Exhibit A1
Staff Report
Wilsonville Planning Division
Delta Logistics Site Expansion

Development Review Board Panel 'A'
Quasi-Judicial Public Hearing
Amended and Adopted May 8, 2023
Added language ***bold italics underline***
Removed language ~~struck through~~

Hearing Date:	May 8, 2023
Date of Report:	May 1, 2023
Application No.:	DB22-0007 Delta Logistics Site Expansion
Request/Summary:	The requests before the Development Review Board include a Stage 1 Preliminary Plan, Stage 2 Final Plan, Site Design Review, Waivers, Class 3 Sign Permit, Type C Tree Removal Plan, Standard SROZ Map Verification, Standard SRIR Review, and Variance.
Location:	9710 SW Day Road and 9835 SW Commerce Circle. The property is specifically known as Tax Lots 600 and 601, Section 2B, and Tax Lot 400, Section 2CA, Township 3 South, Range 1 West, Willamette Meridian, Washington County, Oregon
Owner/Applicant:	Delco Holdings, LLC, dba Delta Logistics, Inc. (Contacts: Vladimir Tkach, Igor Nichiporchik)
Authorized Representative:	Mackenzie (Contact: Lee Leighton, AICP)
Comprehensive Plan Designation:	Industrial
Zone Map Classification (Current):	Future Development 20 Acre (FD-20)
Zone Map Classification (Propos

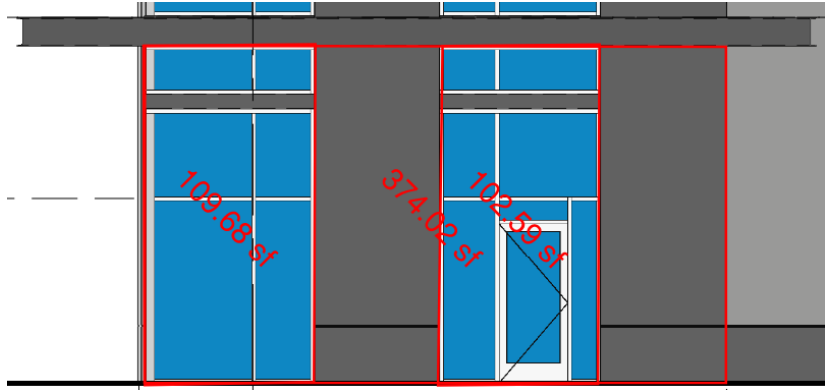
<p><u>Response:</u> The proposed path from the sidewalk in SW Day Road crosses the vehicular drive aisle for the north parking area, which is free from heavy truck traffic, at a location with good visibility for pedestrian safety. It connects to an ADA-compliant sidewalk ramp next to the building, extending south to the Primary Building Entrance on the west side of the office endcap. The Primary Building Entrance, located on the west side of the office endcap, includes glass industrial storefront 7 feet wide with 5.5-foot-wide reveal panels on both sides, for a total width of 18 feet. Height to the top of canopy at the building entrance is 16 feet.</p>		
Location	150 feet, maximum from right-of-way of an Addressing Street, see Figure CC-7.	150 feet, maximum from right-of-way of a Supporting Street, if there is no Addressing Street Frontage, see Figure CC-7.
<p><u>Response:</u> The Primary Building Entrance, at the northwest building corner, is within 150 feet from SW Day Road, an Addressing Street.</p>

Visibility	Direct line of sight from an Addressing Street to the Primary Building Entrance.	
<p><u>Response:</u> The proposed public entrance is visible from points along the SW Day Road frontage.</p>		
Accessibility	Safe, direct, and convenient path from adjacent public sidewalk.	
<p><u>Response:</u> The proposed path provides a direct connection from the sidewalk and crossing of the circulation area for the north parking area is clearly marked with striping.</p>

Development Standards Applying to Waysides
 Subsection 4.134 (.12) C. 1.-2.

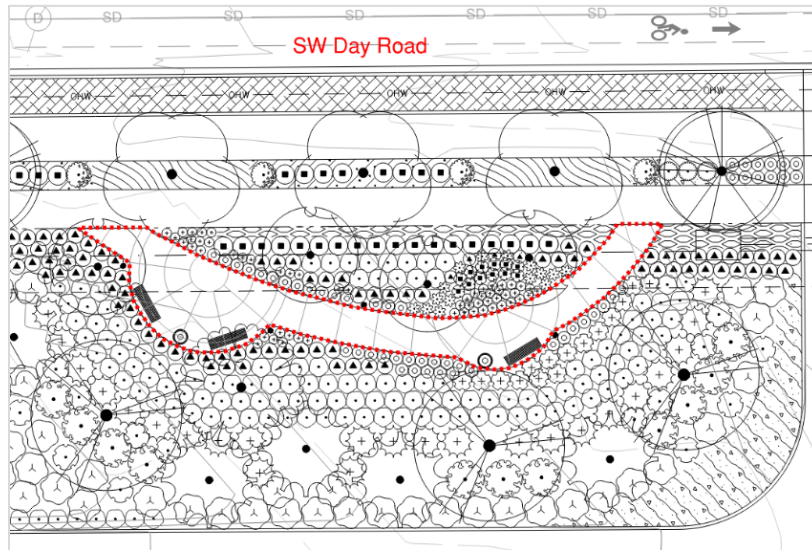
B43. As shown in the illustration, below, the proposed wayside is exclusive of the required landscape screening and has at least one minimum dimension of 20 feet along the looping path on its southwest, south, and southeast sides. Perimeter landscaping does not obscure visual access to the wayside from the SW Day Road right-of-way; dense landscaping behind the wayside, on its south side, visually separates it from the outdoor semi-tractor trailer parking/storage interior to the site.

Subsections 4.134 (.08) and 4.118 (.03) A.

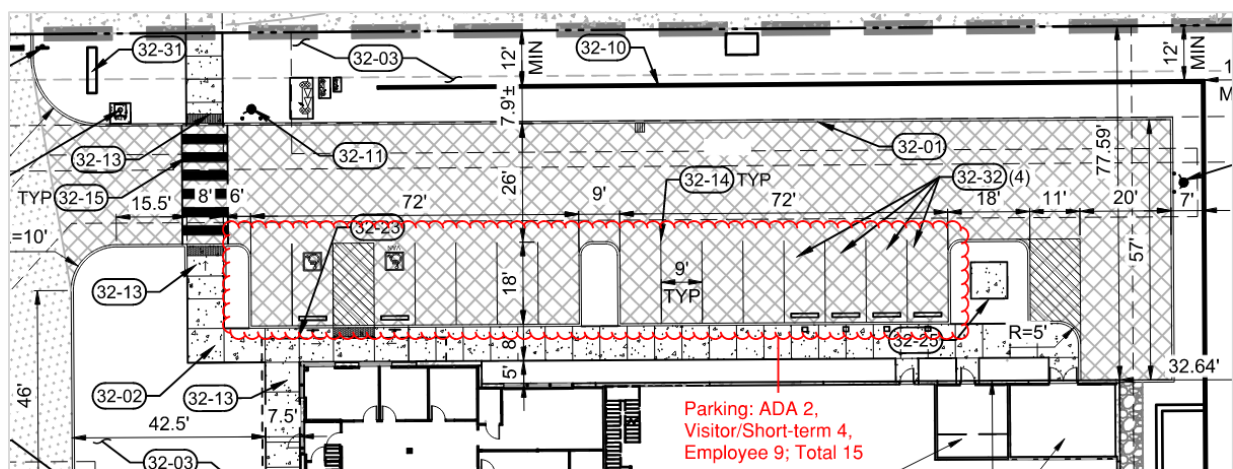
- D1.** The applicant requests to waive the vehicle parking area design standards from the Coffee Creek Design Overlay District. Subsection 4.134 (.11), Table CC-3, 4. Parking Location and Extent/Addressing Streets allows 16 spaces maximum with an adjustment to 20 spaces on an Addressing Street. This parking is limited to one double-loaded bay to be designated for short-term (1 hour or less), visitor, and disabled parking only between the right-of-way of the Addressing Street and building. This standard is listed as one of three in Section 4.134(.08) Waivers that shall not be waived unless there is substantial evidence in the whole record to support a finding that the intent and purpose of the standard will be met in alternative ways.

The applicant proposes 15 vehicle parking spaces on the north side of the building between the building and Addressing Street SW Day Road, which is less than the maximum of 16 spaces. However, the applicant proposes to designate nine (9) of the 15 spaces for employees, which is not permitted by the standard, thus requiring a waiver.

Retaining Wall – North Section

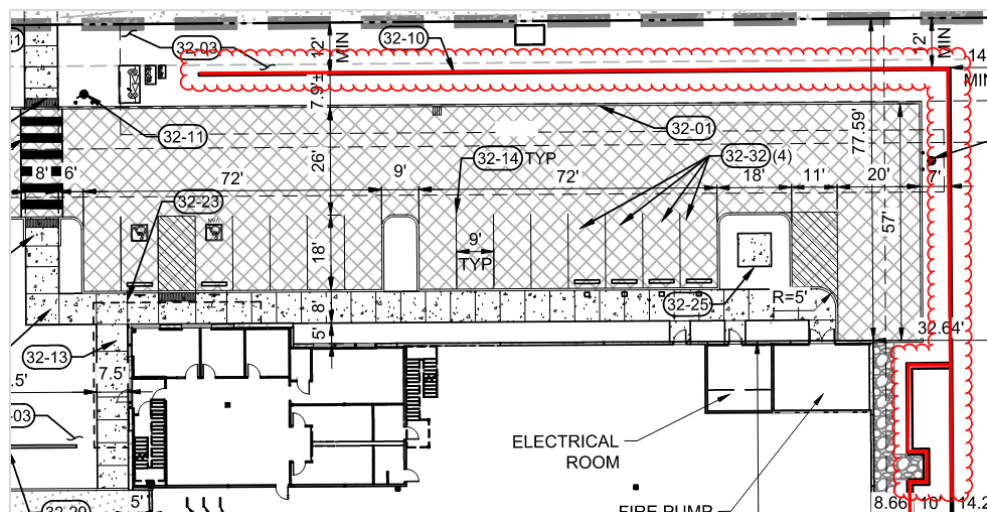
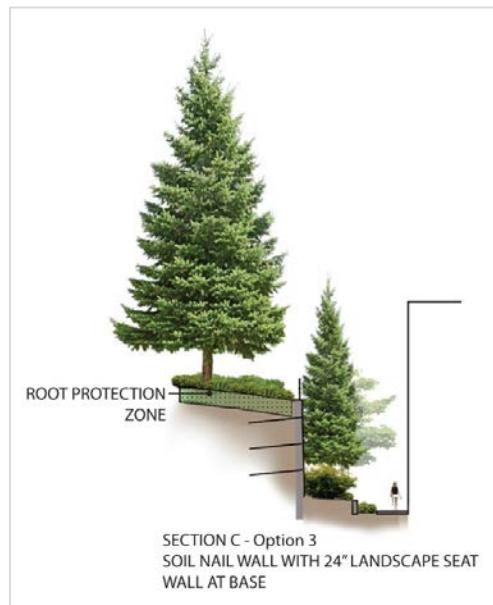
- D3. The applicant requests to waive the maximum retaining wall height standard from the Coffee Creek Design Overlay District. Subsection 4.134 (.11), Table CC-3, 5. Grading and Retaining Walls/Maximum Height/Addressing Streets requires landscape retaining walls to be a maximum of 48 inches tall; there is an allowed adjustment of 20% to 57.6 inches.

As shown in the illustration below, the applicant proposes a retaining wall in the eastern part of the site, forming a “U” shape wrapping around the building and vehicle parking areas. The central part of the wall is parallel to the eastern site boundary, with north and south wings extending west parallel to the north and south property lines. The north section of the retaining wall is located parallel to SW Day Road south of the right-of-way on the north side of the parking area drive aisle; the top of wall is proposed to be even with the finished grade of the right-of-way. The retaining wall is proposed to exceed four (4) feet in height over a span of approximately 785 feet, including roughly 182 feet in the north, 450 feet in the center, and 153 feet in the south sections. The wall height varies from grade at the west extent of the north wall to 18.7 feet at the northeast corner of the wall, 18.7 feet along the entire eastern (central) segment to the southeast corner, and descending to grade at the west extent of the south wall. The north segment of the retaining wall will not be visible from the SW Day Road right-of-way, except at its northeast corner and along the eastern portion that is not obscured by the building. It will be visible from within the north parking area and from the walkway to the office endcap at the northwest part of the building. The rest of the eastern segment and the southern segment of the wall will only be visible from within the site.

Building Sign Area Allowed
Subsection 4.156.08 (.02) B. 1.

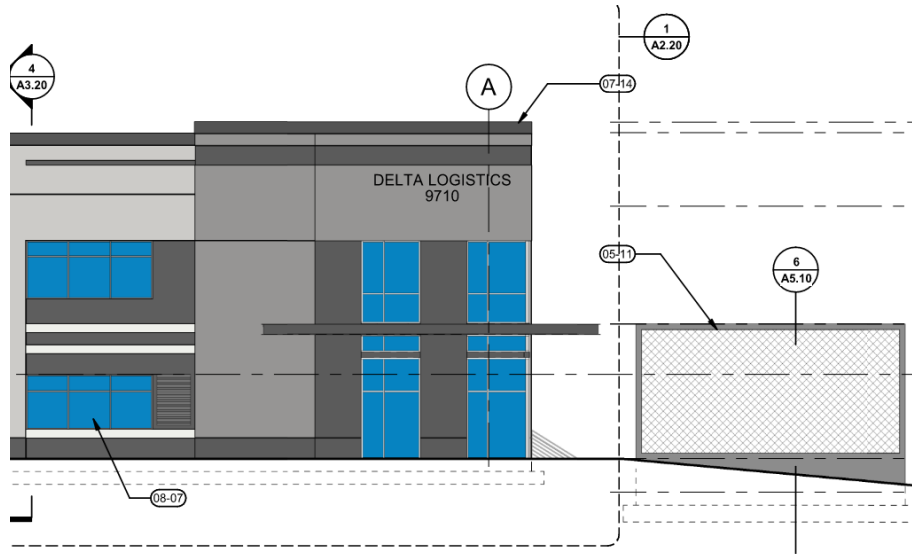
E19. The north façade of the proposed building is roughly 180 feet (ft) in length. For facades greater than 72 linear ft, the allowed sign area is 36 square feet (sf) plus 12 sf for each 24 linear feet or portion thereof greater than 72 ft up to a maximum of 200 sf. Therefore, the allowed sign area is 36 sf plus 60 sf (180 ft – 72 ft = 108 ft / 24 ft = 4.5 ft (rounded to 5 ft); 5 ft x 12 sf = 60 sf), or a total of 96 sf. As the dimensions of the proposed wall sign are not shown on the applicant’s plan sheets (Exhibit B2), a condition of approval has been added to ensure the sign area does not exceed the allowed area of 96 sf.

Section 4.139.04 (.01) through (.22)

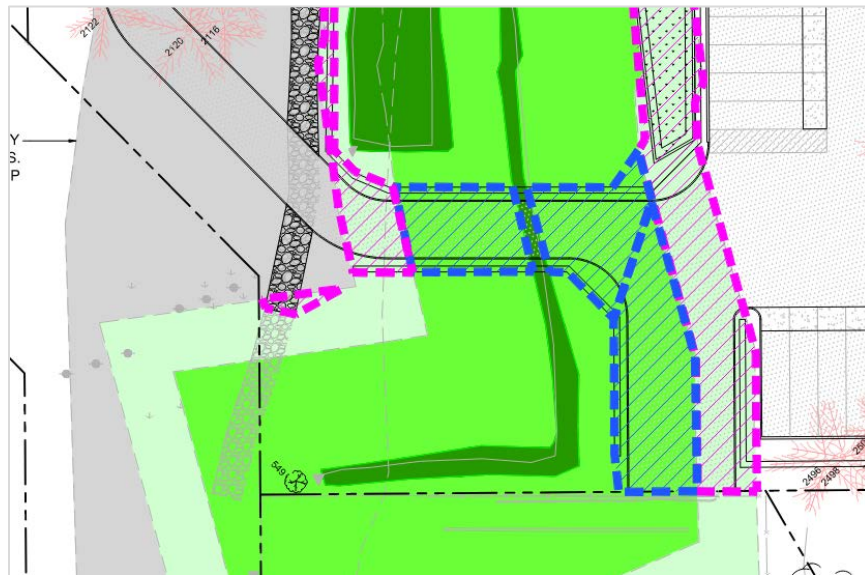
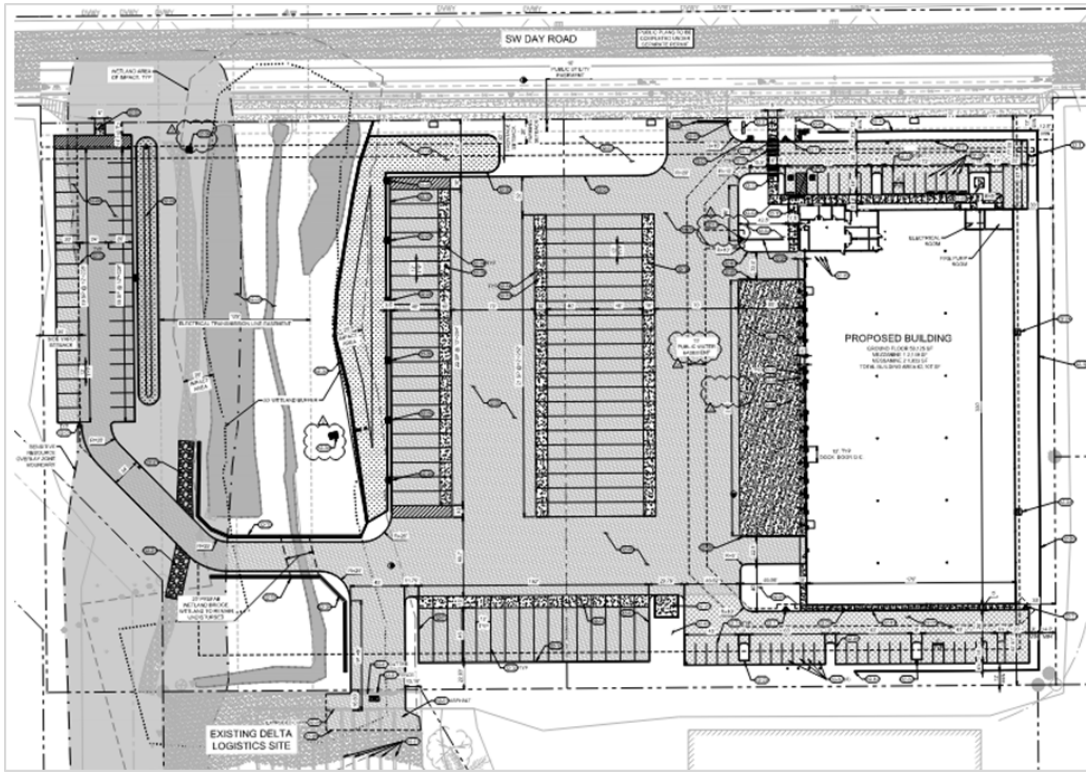
I4. As shown in the illustrations below, the applicant's preferred site design Option 1 proposes to cross the SROZ on the subject property with a drive aisle to enable access to the upland portion of the site, which contains approximately 0.95 acre, located west of the SROZ and

- I6.** Access to and development of the western portion of the subject property via internal circulation as proposed in the applicant's site design Option 1 is encumbered by location of the SROZ and its Impact Area. This encumbrance exists regardless of the owner and would apply the same for any owner of the subject property. However, access to the western portion of the subject property is achievable via a Required Supporting Street along the west property boundary as shown in the Regulating Plan (Figure CC-1). This situation also applies to any owner of the property. None of three (3) site design options presented by the applicant includes building the Supporting Street or dedicating right-of-way to allow its construction in the future. Thus, this variance condition is not met.
